BEAUX-ARTS INSTITUTE OF DESIGN MAY 1948 VOL. XXIV NUMBER THREE SCHOOL YEAR 1947-1948

THE LLOYD WARREN SCHOLARSHIP — 1948 (35th Paris Prize in Architecture)

FIRST PRELIMINARY COMPETITION—"A FARM PRODUCE OUTLET"

REPORT OF THE JURY - BY CALEB HORNBOSTEL

- 67. J.K.SINCLAIR, PRINCETON UNIVERSITY
- 68. L.DEMOLL, UNIVERSITY OF PENNSYLVANIA
- 69. R.W.REISACHER, PRINCETON UNIVERSITY
- 70. MARK G. HAMPTON, GEORGIA SCHOOL OF TECHNOLOGY

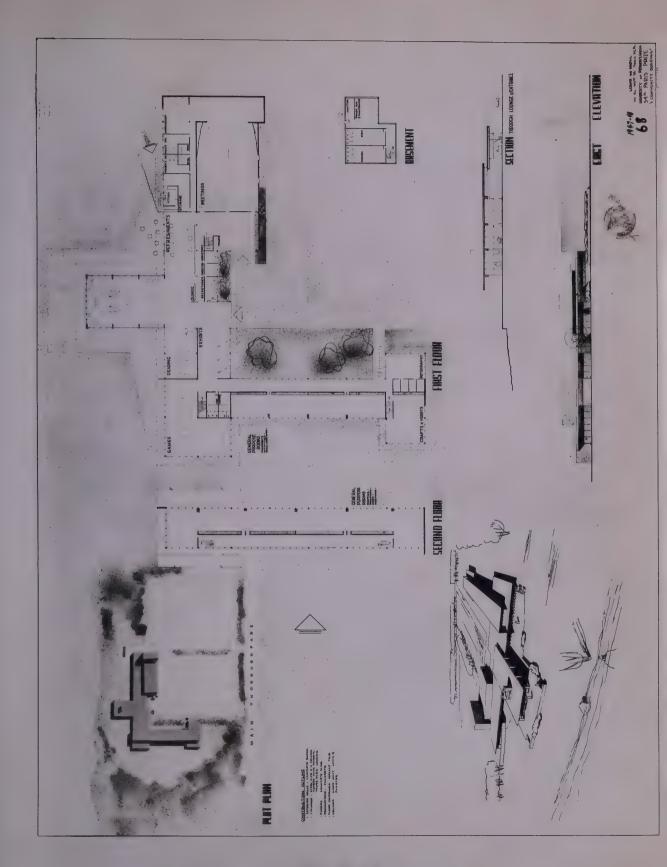
OF THE TWELVE COMPETITORS SELECTED FOR THE FINAL COMPETITION, THE FOUR DESIGNS PUBLISHED WERE AMONG THE BEST. J.K.SINCLAIR, PRINCETON UNIVERSITY, WAS ONE OF THE FEW COMPETITORS WHO TOOK ADVANTAGE OF THE SLOPING SITE TO DEVELOP A SPLIT LEVEL SCHEME FOR THE MEETING ROOMS AND THE GENERAL PURPOSE ROOMS. THE AUDITORIUM, RECREATION ROOM AND WORK ROOM WERE ALL CLOSELY RELATED AND THE CORRIDOR SPACES KEPT TO THE MINIMUM. HE HAD A COMPACT PLAN AND AS ONE ENTERED ALL THREE MAJOR ELEMENTS WERE EASILY DISCERNABLE. THE POINTS CRITICIZED WERE THE PARKING COMPLETELY ACROSS THE FRONT OF THE BUILDING, AND THE TIGHT LOBBY CONDITION AT THE ENTRANCE TO THE AUDITORIUM.

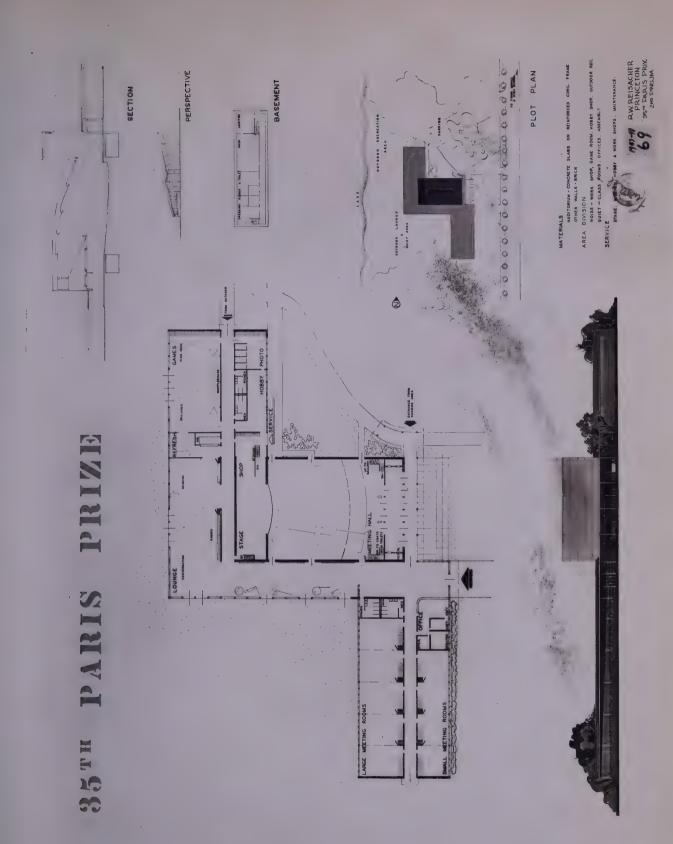
L.DEMOLL, UNIVERSITY OF PENNSYLVANIA, HAD A MORE OPEN TYPE OF PLAN, WITH THE LOUNGE ROOMS AND GAME ROOMS FACING THE LAKE. THE SEPARATION OF THE AUDITORIUM AND MAIN ENTRANCE WAS NOT FOUND OBJECTIONABLE INASMUCH AS THERE WAS A TIE BETWEEN THE FOYER OF THE AUDITORIUM AND THE LOUNGE TOWARD THE REAR. THE JURY FELT THE GENERAL PURPOSE WING WAS UNNECESSARILY ELONGICED AND HAD THE ROOMS BEEN DIFFERENTLY PROPORTIONED, A MORE COMPACT PLAN WOULD HAVE RESULTED.

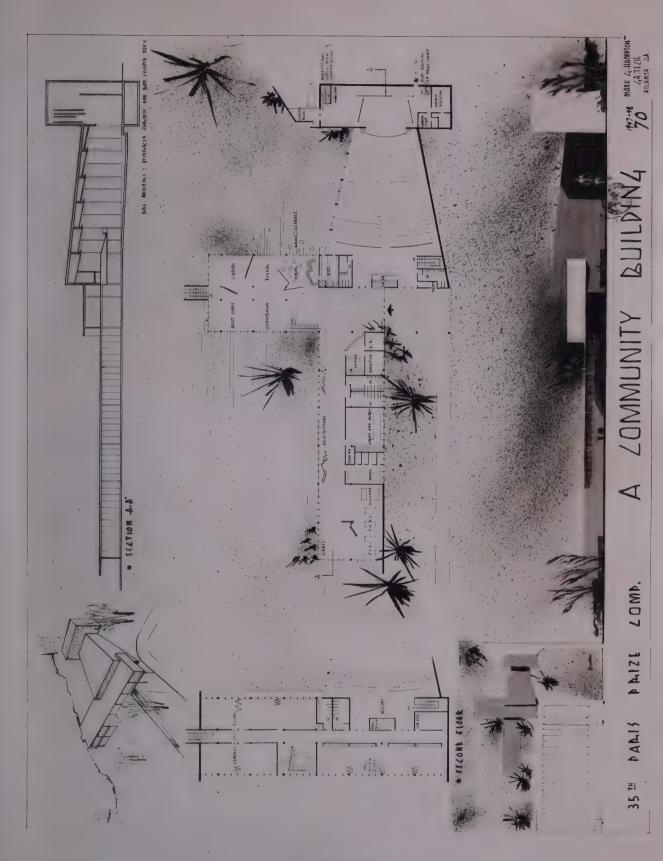
R.W.Reisacher, princeton university, kept the parking to one side and provided a close connection between the auditorium and the remainder of the building. Side exits from the auditorium opened into the exhibition space permitting discussion and social activities after the close of a meeting. Lounge and game rooms faced the lake, and general purpose rooms were kept as a compact unit toward the road. It was felt the game room was rather isolated and would be diffigult to control from the director's office. The view of the long exhibition corridor upon entering the main entrance was not considered a desirable feature.
